THE ROVER COMPANY LIMITED

LAND-ROVER SERVICE NEWS LETTER

No. 11

June 1961

Fig. 1—Early type, pendant ball joint.

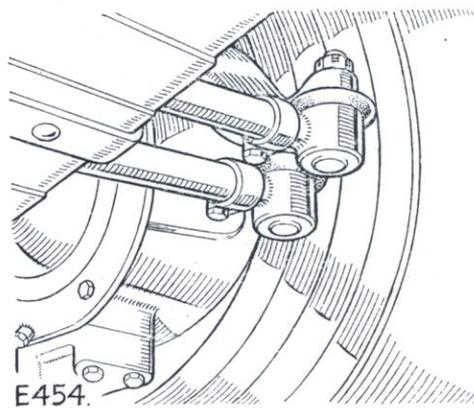
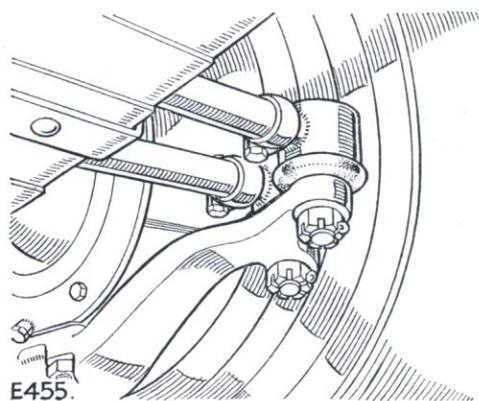
Introduction of steering ball joints fitted in the non-pendant position, that is with the ball joint above steering lever.

Early type: steering levers fitted to top of swivel housings and ball joints below levers.

Late type: steering levers fitted to bottom of swivel housings and ball joints above levers.

See Figs. 1 and 2 below.

Swivel pin and steering levers not interchangeable as individual items, they can, however, be fitted in pairs provided either the swivel pin housing complete is changed for the latest type, or studs are fitted in the bottom position of the existing swivel pin housing. Studs required are 6 off 508152, 2 off 508153. It is most important that the latest type steering levers are not fitted to an early type housing in the lower position with the existing bolts; the studs detailed above including the special fitting studs 508153 must be fitted. This prevents any tendency for movement between lever and housing which could give rise to premature breakage of the bolts with the possibility of serious damage.

Steering track rod, not interchangeable, overall length altered as follows:

- Pendant type ball joint 46 $\frac{1}{4}$ in. (123 cm)
- Non-pendant type ball joint 45 $\frac{5}{8}$ in. (116 cm)

- Pendant type ball joint 43 $\frac{3}{4}$ in. (111 cm)
- Non-pendant type ball joint 43 $\frac{1}{8}$ in. (109 cm)

Fig. 3—Diagrammatic layout of screen washers. R.H.D. illustrated.

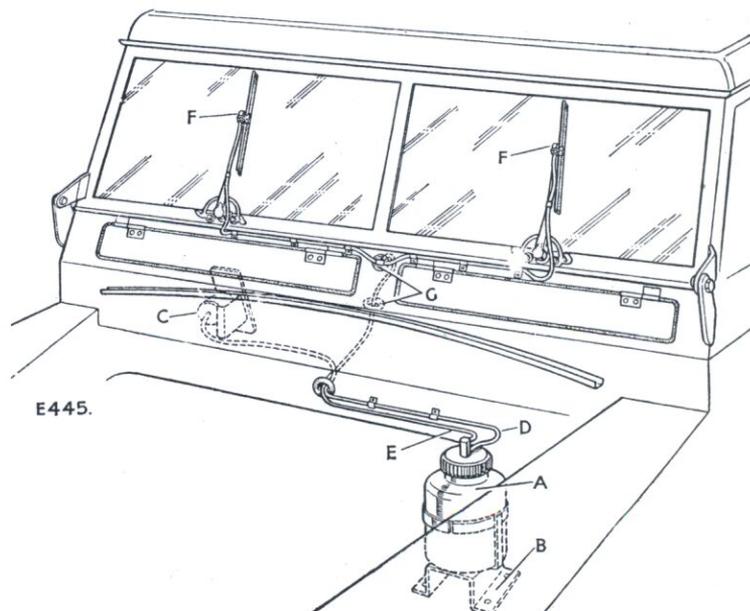
Complete kits of parts for fitting either one or two windscreen washer jets to the Land-Rover Series II are now available from our Parts Department under Part No. 526358.

The kit is complete with fitting instructions, and can easily be fitted to any Series II model. See Fig. 3.
